Merged Document Report

Application No.: PL9259

Description :	
Address :	
Record Type :	PLAT

PLAT OF LEXINGTON VILLAGE LOT 6R

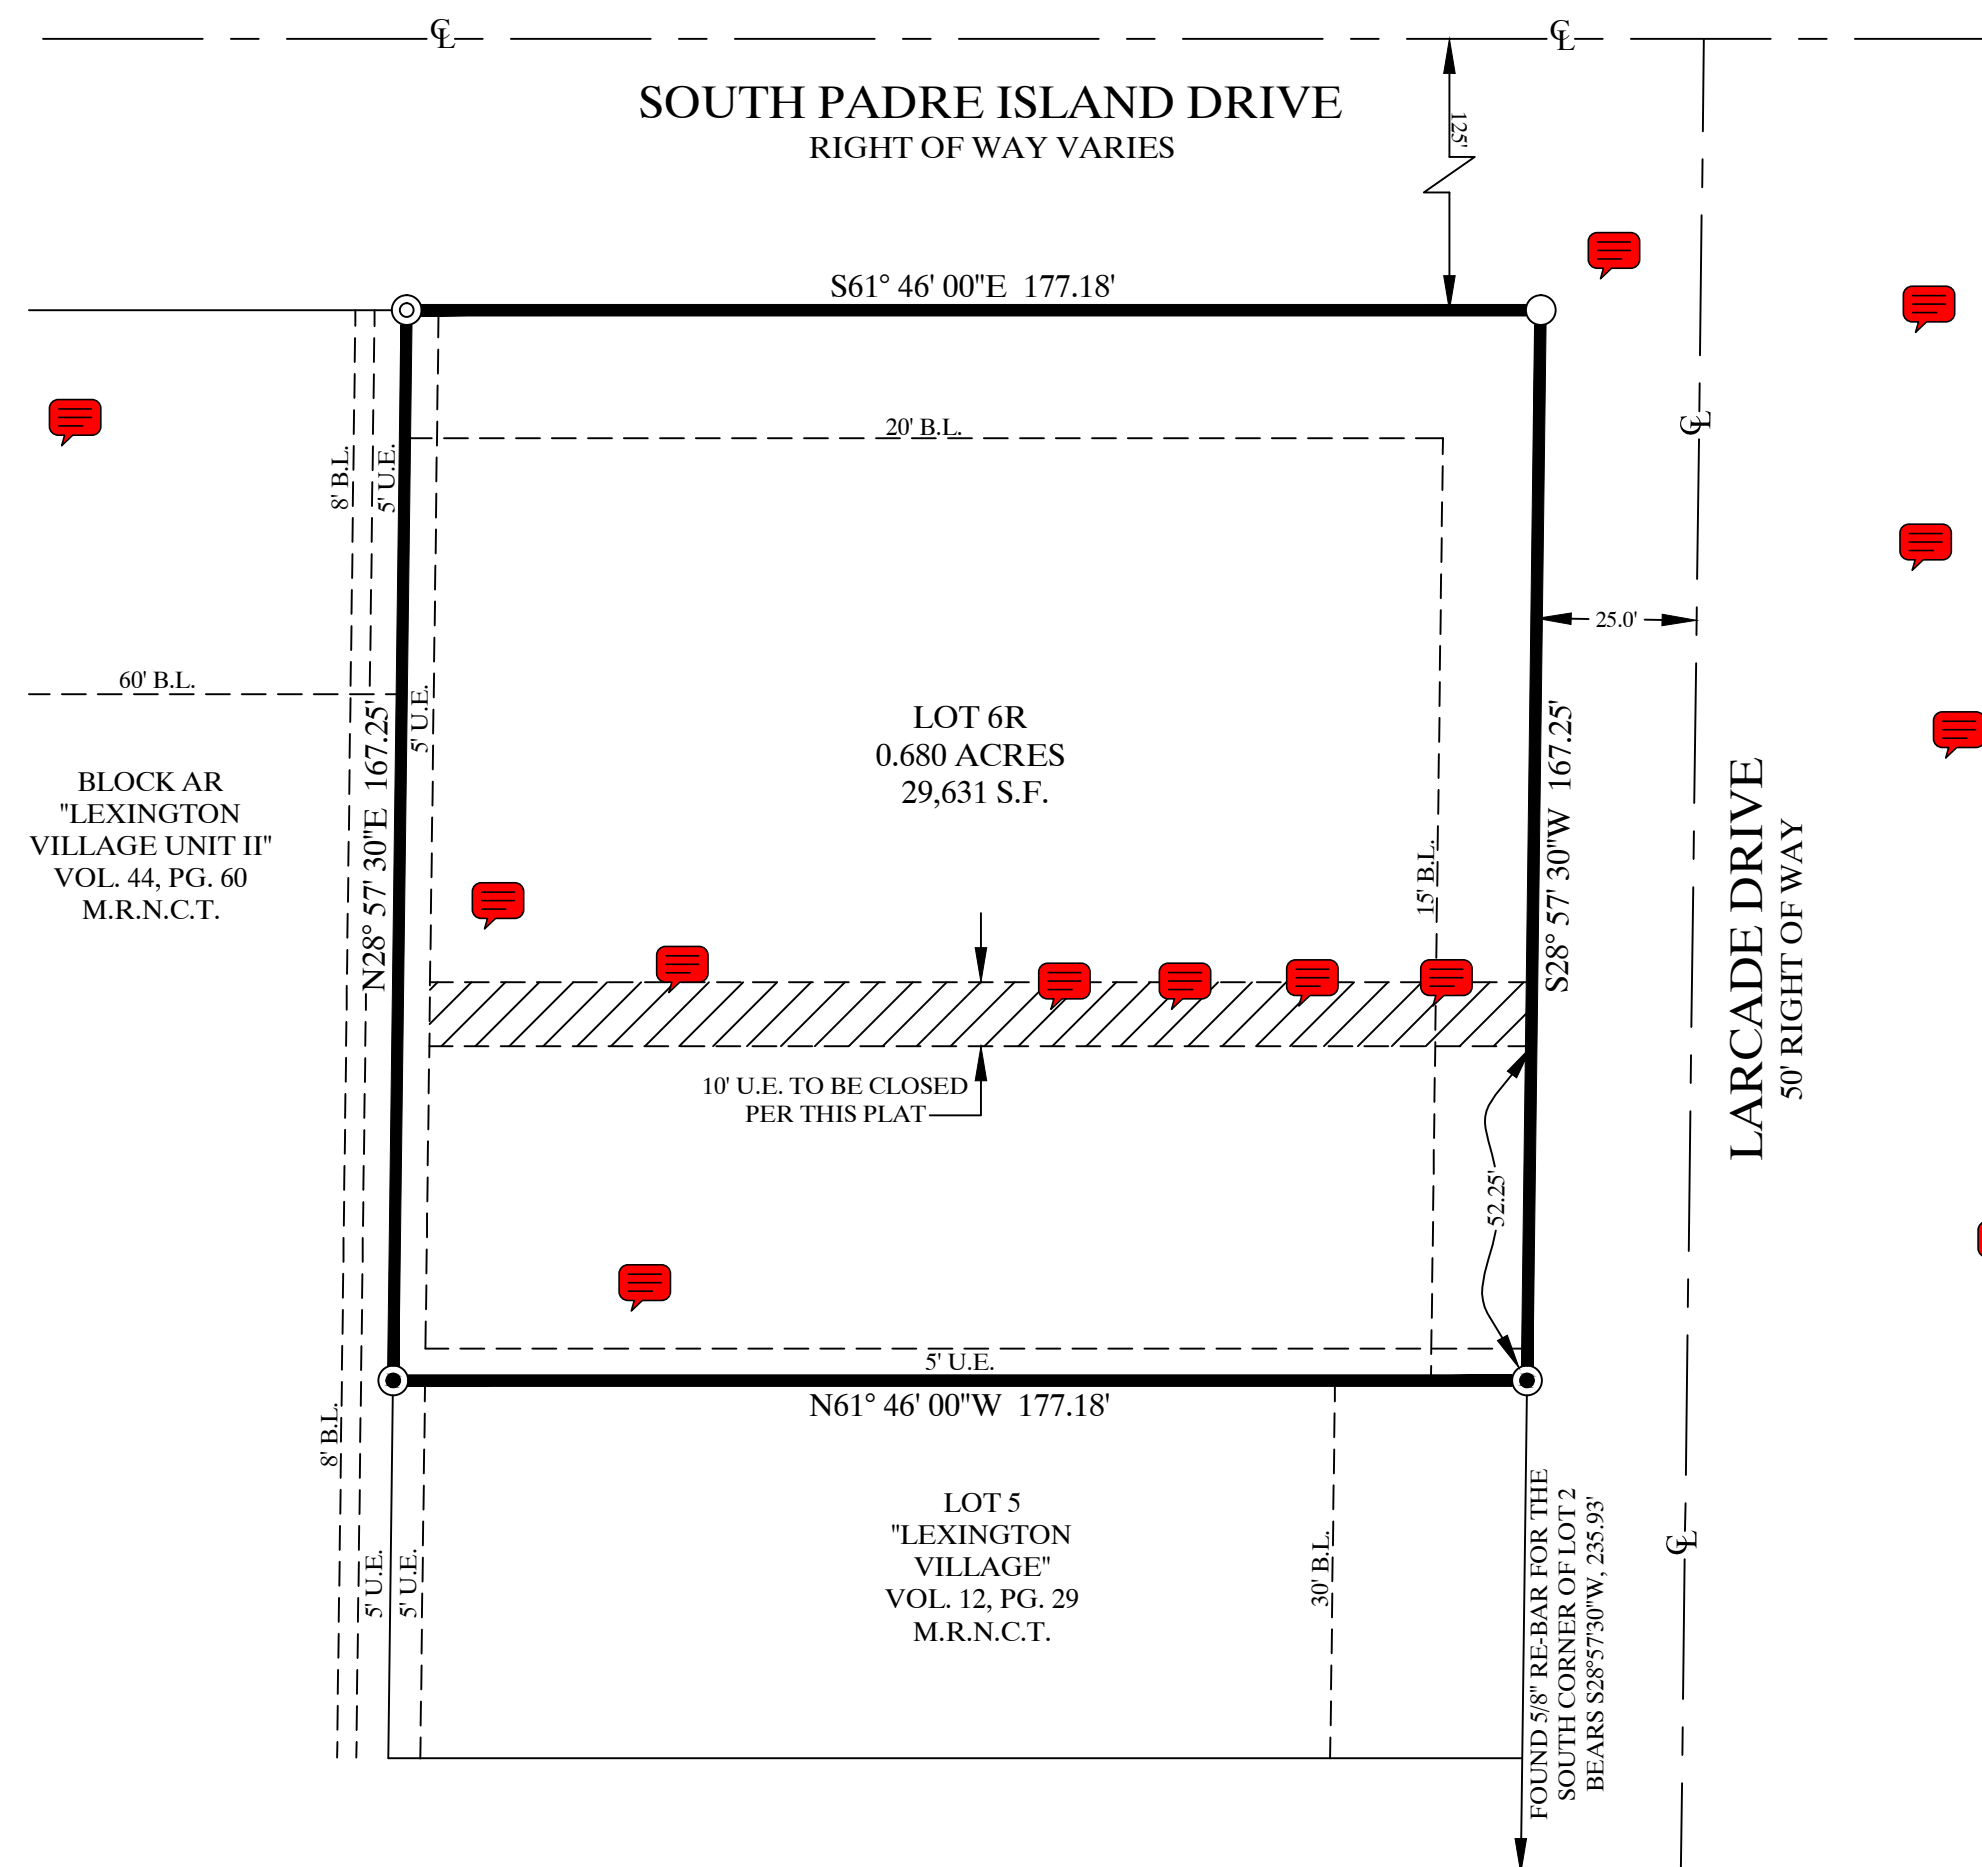
Comment ID	Page Reference	Annotation Type	Author : Department	Status	Review Comments	Applicant Response Comments
1	Plat	Note	Bria Whitmire : DS	Closed	Improvements Required for Recordation, per UDC 8.1.4. A. Streets: no Sidewalks: no B. Water: no (EACH lot must have individual access and provide connectivity to neighboring lot) Fire hydrants: not for platting, possibly for site development (nearest hydrant must be 300 feet for commercial, 600 for residential) C. Wastewater: no (EACH lot must have individual access and provide connectivity to

Comment ID	Page Reference	Annotation Type	Author : Department	Status	Review Comments	Applicant Response Comments
					<p>neighboring lot)</p> <p>D. Stormwater: no, however site development must mitigate any increase of stormwater runoff-post development flow cannot exceed pre development flow</p> <p>E. Public open space: no (UDC 8.3)</p> <p>F. Permanent monument markers: no</p> <p>Please note, improvements required should be constructed to city standards, found in Article 8 and the IDM.</p>	
2	Plat	Note	Bria Whitmire : DS	Closed	Driveway Permits (sizing and spacing) and ROW Permits (any work in ROW including utility tie-ins) to be obtained from Public Works at Link	
3	Plat	Note	Mina Trinidad : DS	Closed	Informative Note: Previous plat has a 30' B.L. off South Padre Island Drive and Larcade Drive.	
4	Plat	Note	Mina Trinidad : DS	Closed	(Informational) CCPD has no comments.	
5	Plat	Note	Mina Trinidad : DS	Closed	(Informational) Astound has no objections and does not have any facilities located within the proposed easement to be closed.

7	Plat	Note	Mina Trinidad : DS	Closed	<p>(Informational) TxDOT: • TxDOT permits will be issued in accordance with access management standards and all applicable state and federal laws, including relevant rules and regulations. Considerations will include access connection spacing, materials, geometrics, accessibility, and other design specifications, as well as the impact on drainage and</p>

8	Plat	Note	Mina Trinidad : DS	Closed	<p>(Informational) CCW: Water: Water construction is not required for platting (UDC 1.2.1.D & 8.2.6; Water Distribution Standards).</p> <p>Wastewater: Wastewater construction is not required for platting (UDC 1.2.1.D & 8.2.7; Wastewater Collection System Standards).</p>	
9	Plat	Note	Mina Trinidad : DS	Closed	(Informational) TxDOT: Does not appear to involve State ROW.	
10	Plat	Note	Mina Trinidad : DS	Closed	(Informational) Engineering Services has no comment.	
11	Plat	Note	Mina Trinidad : DS	Closed	<p>Update 05/11/26: Brister Surveying's response to below comment: "Owner working to get gas line relocated." Sent this response comment sheet to Keith R. and he responded with, "Gas has no additional comments for this plat." PDF of Email in attachments.</p> <p>Gas Department: (Keith R.) The Gas Department will need to re-route an existing 2" gas main that is in the utility easement that is being closed. The re-route will cost \$6,046.92 paid before work is done.</p>

Comment ID	Page Reference	Annotation Type	Author : Department	Status	Review Comments	Applicant Response Comments
13	Plat	Note	Mina Trinidad : DS	Closed	(Informational) GIS: Plat closes within acceptable engineering standards.	
14	Plat	Note	Mina Trinidad : DS	Closed	(Informational) Parks and Recreation Department: No fees as no newly proposed residential dwelling unit shown to be applied to plats project scope. Reasoning for plat described as "for new building construction." Plat further proposes the combination of 2 lots for the one, to use for commercial use, then including a close to the 10 foot easement inside the property.	
15	Plat	Note	Mina Trinidad : DS	Closed	(Informational) CCRTA: This plat is not located along any existing or planned CCRTA bus service routes.	
16	Plat	Note	Mina Trinidad : DS	Closed	(Informational) 10' buffer yard required off of the residential side during building permit phase.

17	Plat	Note	Mina Trinidad : DS	Closed	(Informational) Spectrum is currently aerial in the rear utility easement and sees no conflict within the proposed work zone.	
18	Plat	Note	Mina Trinidad : DS	Closed	(Informational) Equistar Pipeline will not be involved and has no comments.	
19	Plat	Note	Mina Trinidad : DS	Closed	(Informational) Public Works - Stormwater: No comments.	
20	Plat	Note	Mina Trinidad : DS	Closed	<p>(Informational) Fire: All code reference is based on currently adopted International Fire Code (IFC) 2021 and Corpus Christi Water Distribution Standards</p> <p>Plat: -Commercial Development shall have a fire flow of 1,500 GPM with 20 psi residual Fire hydrant every 300 feet and operational.</p> <p>-If the property use is commercial, the fire flow requirements shall be a minimum of 1,500 GPM at 20 PSI residual. If the property use is industrial, the fire flow requirements shall be a minimum of 3,000 GPM with 20 psi residual. The requirement for each shall be resolved at the Development Service or Building phase of the project.</p> <p>-507.5.1 (amendment) Where Required: All premises, other than one-family detached dwellings, where buildings or portions of buildings are located more than 150 feet from a fire hydrant shall be provided with approved on-site hydrants and water mains capable of supplying the fire flow require by the fire official. The minimum arrangement being so as to have a hydrant available for distribution of hose to any portion</p>
